# STRATEGIC PETROLEUM RESERVE

## ENGINEERING CHANGE PROPOSAL

| ECP NUMBER | TITLE |
|---|---|
| SJ-M/O-4638 | **Removal of Thermal Pressure Safety Valves (PSV)** |

Subject: REVIEW OF ECP SJ-M/O-4638
"REMOVAL OF THERMAL PRESSURE SAFETY VALVES"

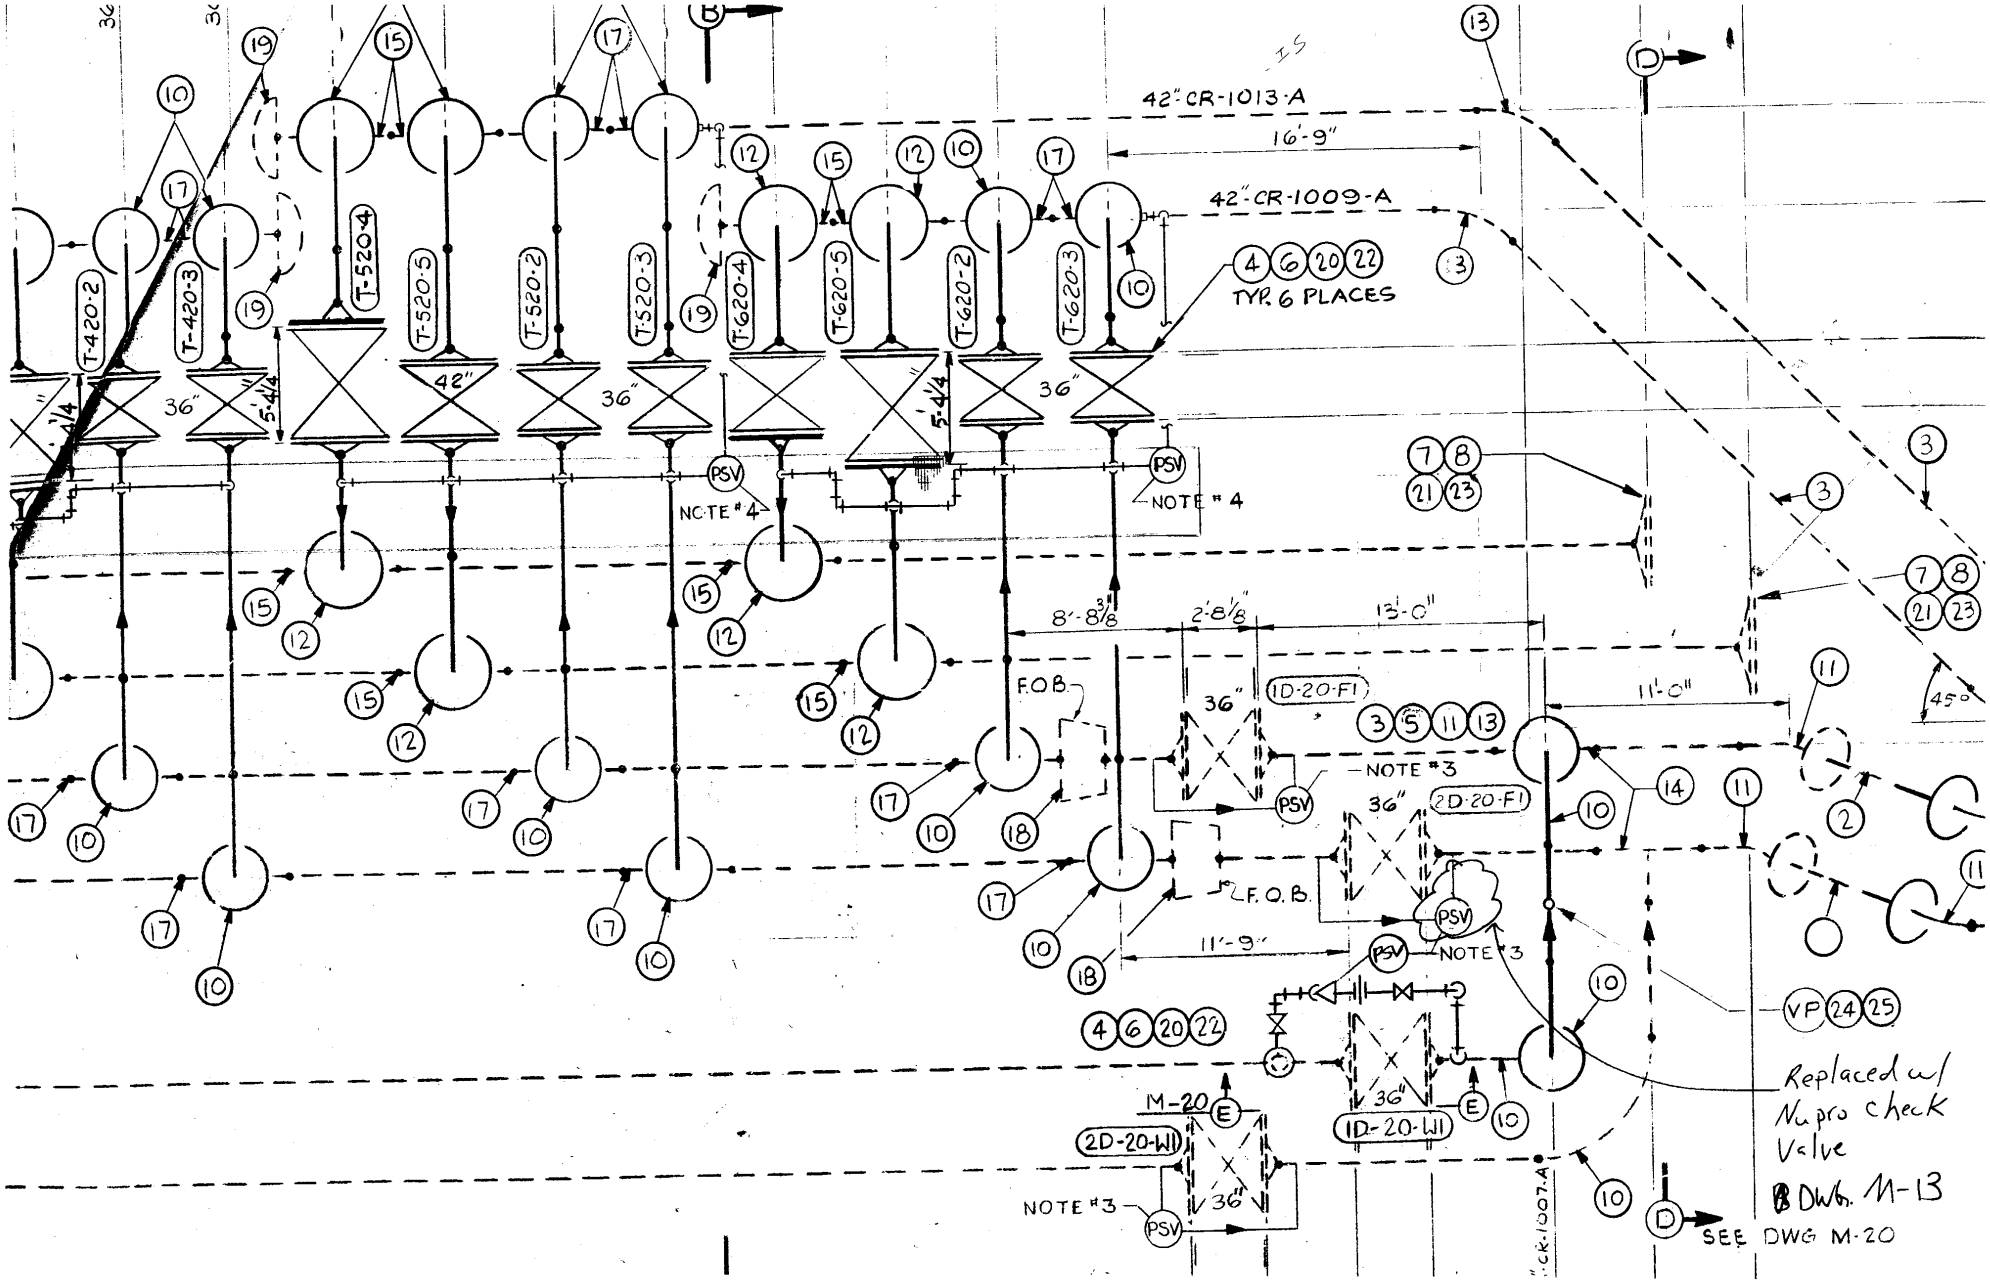
**Relief valves were replaced with Nupro differential check valves. The check valves open at 1 psi of differential pressure. The tag numbers of relief valves removed and replaced with 1psi check valves are as follows: PSV-T-720, PSV-T-1020, PSVD-103, PSVD-107, PSV-2D20F2, PSV-2D20F1, PSV-1D20F2, PSVD-211, PSVD-207, PSVD-203, PSVD-111, and PSV-T-820.**

42" CR-1013-A
16'-9"
42" CR-1009-A
TYP. 6 PLACES
T-420-2
T-420-3
T-520-4
T-520-5
T-520-2
T-520-3
T-620-4
T-620-5
T-620-2
T-620-3
36"
42"
5'-4¼"
PSV
NOTE #4
8'-8⅜"
2'-8⅛"
13'-0"
11'-0"
45°
F.O.B.
1D-20-F1
2D-20-F1
NOTE #3
11'-9"
VP
M-20
2D-20-W1
1D-20-W1
"CR-1007-A
Replaced w/ Nupro check Valve
DWG. M-13
SEE DWG M-20
